DRAFT AMENDMENT TO PARRAMATTA DEVELOPMENT CONTROL PLAN 2023

EXPLANATORY NOTE

Associated with the Planning Proposal is a proposed draft amendment to the Parramatta Development Control Plan (DCP) 2023. At its Meeting on 8 July 2024, Council resolved to amend the Parramatta DCP 2023 by increasing the tower setback for the subject site on the eastern side from 3 metres to 6 metres from the podium. (Described in the table below):

Figure 9.5.1.1.2 – City East Block Public Domain

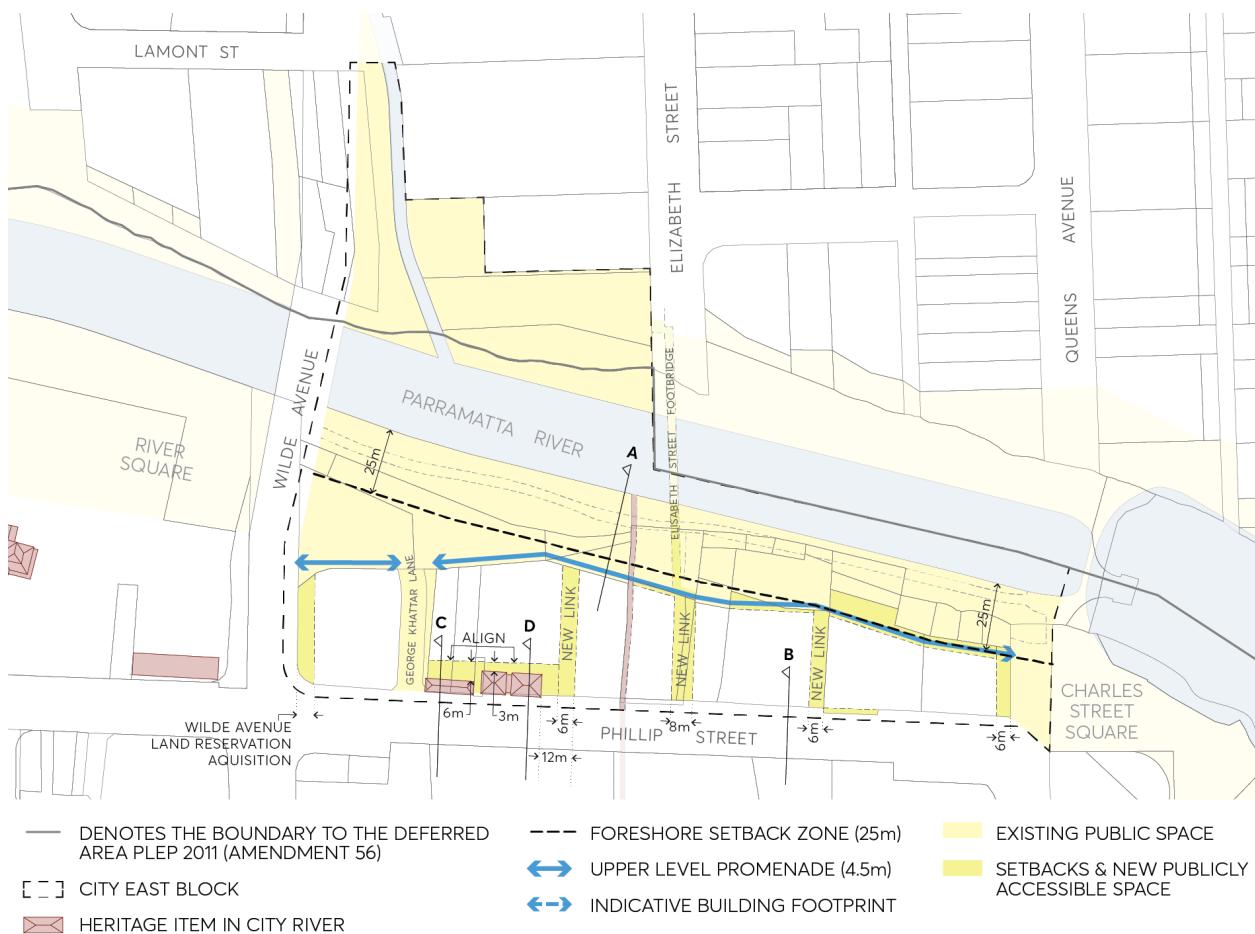
Existing Parramatta DCP 2023	Proposed Parramatta DCP 2023
Eastern Podium setback	6 metres	No change
Eastern Tower setback (90-94 Phillip St only)	3 metres (from the podium wall)	6 metres (from the podium wall)

The increase in tower setback is proposed for this site in order to mitigate the increased height, bulk, scale and wind impacts from the increased height of the building. The increase in tower setback also aligns with the reference scheme associated with the Planning Proposal.
